Immingham Eastern Ro-Ro Terminal

## **Deadline 5 Appendix**

**Associated Petroleum Terminals (Immingham) Limited and  
Humber Oil Terminals Trustee Limited**

Planning Inspectorate Ref: TR030007

**Figure 1 – Purfleet Ro-Ro and Oil Terminals**

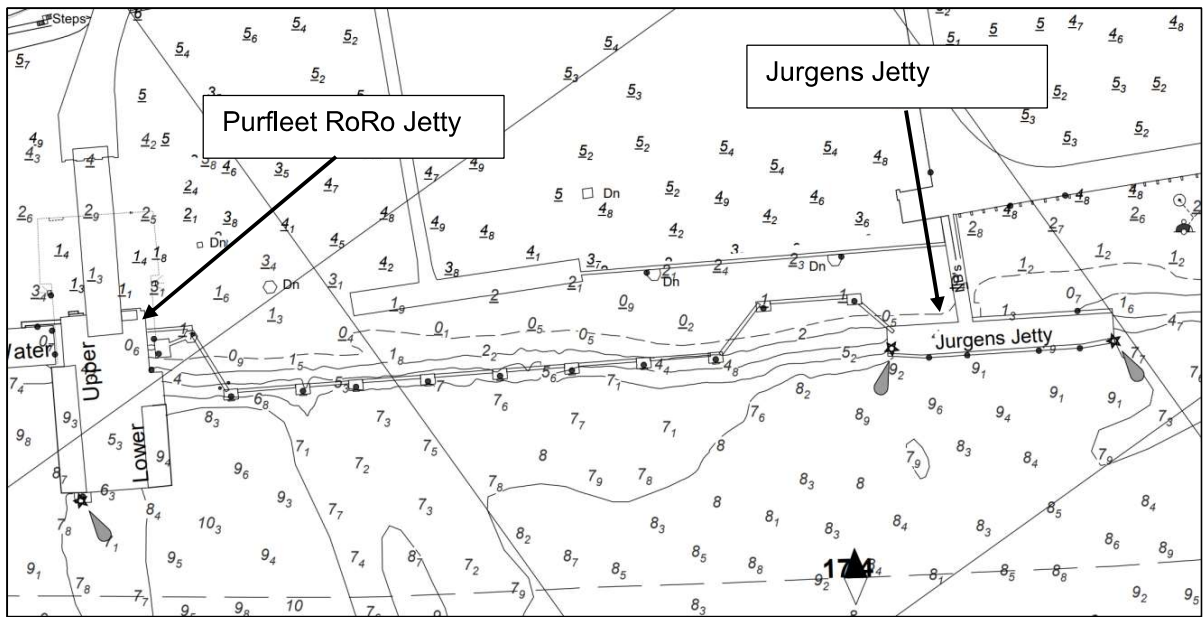
- a) On close inspection of the PLA nautical chart for CLdN Purfleet Ro-Ro Terminal and Jurgens Jetty (located immediate downstream), then it is evident that protection is afforded to the Jurgens Jetty Trunkway and jetty itself by provision of connected mooring piles / dolphins and the bathymetry located beneath the Jurgens Jetty Trunkway which means that errant Ro-Ro vessels bound to or from the Purfleet Ro-Ro Terminal would strike the mooring structure and then run aground prior to making contact with the Jurgens Jetty Trunkway at any state of tide. Note that Jurgens Jetty does not handle petrochemicals but imports vegetable oils only, for margarine manufacturing.

- b) Further, the Jurgens Jetty (comprising only one single vegetable tanker berth) is not a suitable comparison to the IOT and Trunkway which itself caters for all petrochemical commodities flowing to and from seven IOT berths and accounts for a significant proportion of UK oil refining imports and the export of refined products for UK-wide distribution. Also, it should be noted that the IOT Trunkway has all its pipework located on the upstream side closest to the proposed IERRT.

- c) Also, in the event that a Ro-Ro vessel has an engine failure either whilst berthing or departing the Purfleet Ro-Ro terminal the tide will naturally set the vessel either onto the Ro-Ro Terminal if the tide is flooding or past the Jurgens Jetty downstream if ebbing. For the IERRT however any failure during ebb tide situations mean IERRT vessels will set either directly onto the IERRT infrastructure (the ability of which to withstand an errant IERRT vessel impact has been questioned but has not been defined by the Applicant) or onto the IOT Finger Pier, or a tanker alongside the IOT Finger Pier or IOT Trunkway.

- d) Also evident from the PLA nautical chart is that fact that the nearby M25 Queen Elizabeth II Bridge has large and substantial impact protection for each of the bridge piers, which is as should be expected for a piece of significant national infrastructure and as should be the case for the IOT. Note that this impact protection also indirectly protects the VOPAK petroleum berths located downstream of the bridge.

- e) Further, in relation to upstream berth of the Purfleet Ro-Ro terminal then the closest berth is the **disused** Esso Berth 2 located at around 135m distance. With regard to Esso 1 berth, approximately 400m further upstream, it should be noted that this serves a small distribution terminal with imported refined products only. The Trunkway is located in bathymetry of very shallow water, and at a position in which an errant vessel is very unlikely make contact with the Esso 1 Trunkway. In any event, the trunkway serves only one berth which in turn serves one distribution site and there are many other distribution terminals along the Thames facilitating various redundancy options.
